Addressing the changes in Table 33-1 for supporting Type 3 and 4 PSEs Inrush.

33.2.7.5 Output current in POWER_UP mode

Figure 33-13— $I_{\text{Inrush-2P}}$ current and timing limits, per pairset in POWER_UP

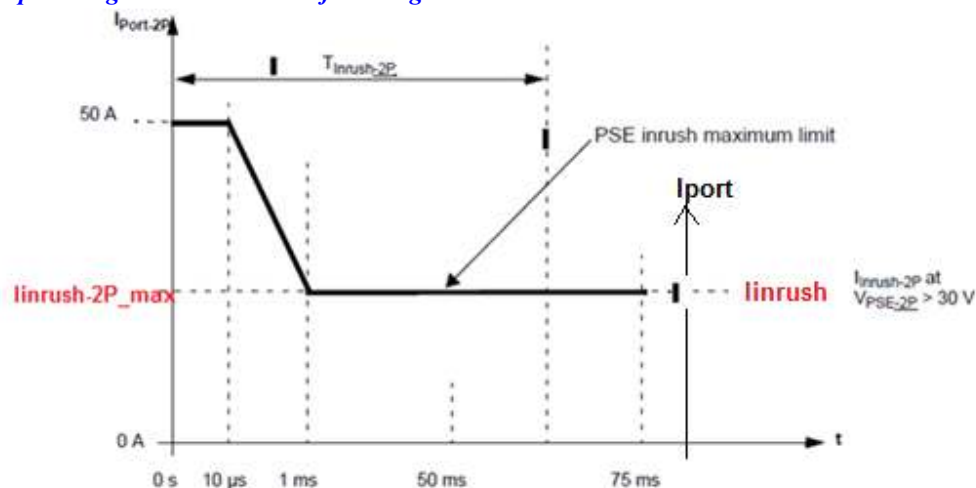
Figure 33-13 was modified to address the effect of end to end pair to pair resistance unbalance on the maximum limit of $I_{\text{Inrush-2P}}$ which by simulation found to be 0.556A adding margin → 0.6Amax. This value will be updated in Figure 33-13 as well to cover requirements below 1msec.

Replace Figure 33-13 with the following:

The PSE inrush maximum limit, $I_{\text{PSEIT-2P}}$, is defined by the following segments:

$$I_{\text{PSEIT-2P}}(t) = \left\{ \begin{array}{ll} 50.0 & \text{for } 0 < t < 10.0 \times 10^{-6} \\ \text{TBD=function of} & \text{for } 10.0 \times 10^{-6} \leq t < 0.001 \\ (t, \text{linrush-2P_max}) & \\ \text{linrush-2P_max} & 0.001 \leq t < 0.075 \end{array} \right\} \text{ A} \quad (33-5)$$

Editor Note: To update the TBD in equation 33-5. Add Equation 33-5a after equation 33-5 to describe the template of figure 33-13 for linrush.
